COUNCIL ASSESSMENT MEMORANDUM

DEVELOPMENT APPLICATION: DA390/2021(1)

1584 AND 1610 FOREST ROAD, ORANGE

RECREATION FACILITY (MAJOR) – CONCEPT AND STAGE 1

Figure 2: Bus Parking within semi-circle entrance way

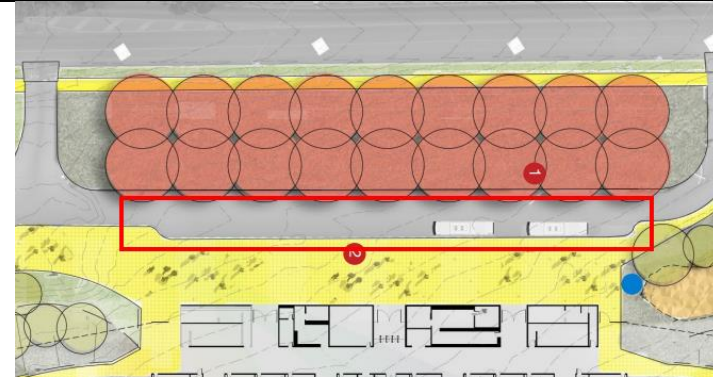
<p>Parking</p> <p><i>While the DA states that there are 1193 spaces provided, 130 of these already exist in Forest Road and 93 (Car Park 5) does not appear to be proposed as part of Stage 1. As previously outlined, of the new 1,063 car spaces, only 184 spaces (around 17%) are accessed via Forest Road, with the residual additional 879 spaces (83%) accessed via Huntley Road. It is clear the supply of parking is both severely lacking and also misaligned with the main demand to the west/new large stadium.</i></p> <p><i>There is a direct correlation between the traffic analysis and the parking assessment and justification in the TIA. Put simply, the assumed 716 vehicular movements associated with the proposed new central 8 fields and existing ovals to the north are stated as being able to be accommodated by the parking provided. The TIA specifically references carparks 1, 2, 4 and 5</i></p>	<p>The types and volumes of vehicle movements associated with stage 1 works being bulk earthworks, civil works, tree clearing, building demolition and category 1 remediation are not expected to substantially impact on the surrounding transport system, with the exception of movements for the delivery of construction equipment/plant at the commencement of works and infrequent load ins and load outs throughout Stage 1. A management plan for the transportation of waste and construction materials to optimise vehicle loads in order to minimise vehicle movements has been recommended to be implemented. These movements are also recommended to be carried out outside of peak hours to avoid any significant disruptions to the road network. Identification of construction vehicle routes, including the use of arterial roads, haulage routes, and access to the site and procedures for oversize and heavy vehicles should also be provided for approval and communicated to all site workers. TfNSW have advised that all construction site access and egress is to only be obtained from Huntly Road.</p> <p>Parking</p> <p>The Council Assessment Report considers the parking requirements for both the general use of the precinct and in major events. The appropriate parking provision is to be determined by Council as outlined in the adopted DCP where no applicable rates exist. In this scenario, the development needs to be accompanied by a traffic impact assessment, which it is. Given no data is available for such a facility in any guidelines, an estimation approach has been used by the traffic consultant that encompasses methods that estimate the traffic state, based on partial observation and a priori knowledge (assumptions) on traffic dynamics. To give a good indication of the anticipated parking provision, the report estimates the traffic generation of the proposed new facility (general operation) based on vehicle usage attributed to the existing 11 playing fields at Sir Jack Brabham Park. Under an extremely worst-case scenario, the traffic generation was also calculated on the basis that all general sporting fields would be in use simultaneously.</p>

Bus parking is not clear.

Bus parking set downs are shown within the access and parking facilities of the football stadium precinct as indicated in RED for clarity:
